# DEFENSE NUCLEAR FACILITIES SAFETY BOARD

## Staff Issue Report

**SUBJECT:** Design Basis Earthquake Ground Motion Criteria for the Hanford Site and Waste Treatment Plant

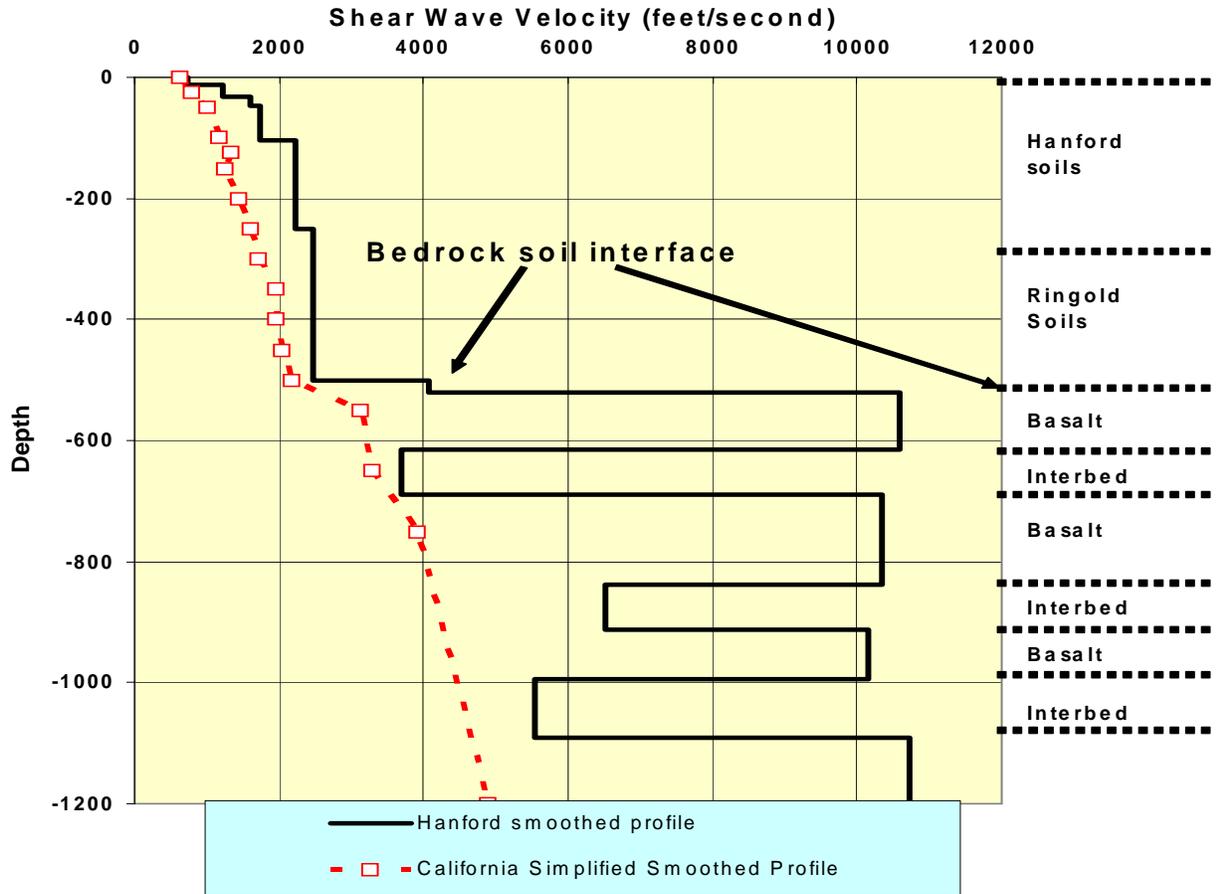
The Board's staff developed Figure 1 from these site response analyses to illustrate the Vs profile for California and the Vs profile used for the Hanford site. It is important to note that the Hanford bedrock Vs profile shown in Figure 1 is based on velocity data taken ~20 km from the WTP site.

However, the Hanford bedrock is not continuous, as seen by the bedrock interbeds shown in Figure 1. The 1996 analysis predicted a significant energy reduction resulting from the arrangement of these bedrock interbeds. This energy reduction counteracted the large soil amplification, resulting in comparable ground motion for Hanford relative to California. Thus the behavior of the bedrock interbeds plays a critical role in determining the site ground motion.

Early assessments conducted by the Board's staff estimated that the site response at Hanford could be about 15 percent greater than that at California sites in the frequency range of 4 to 10 hertz. This was communicated to DOE in the Board's letter of January 21, 2003. However, differences in the characterization of the soils and bedrock at the WTP site could have a significant impact on the difference between the WTP site response and that at California sites. While it may be expected that ground motion changes of up to 15 percent can be addressed by implementing acceptably conservative compensatory design features (e.g., demand/capacity ratio  $\leq 0.85$ ), the same might not be the case if the ground motion were to increase by as much as 50 percent. Thus understanding  $V_s$  for the WTP site soil, basalt, and interbeds is essential.
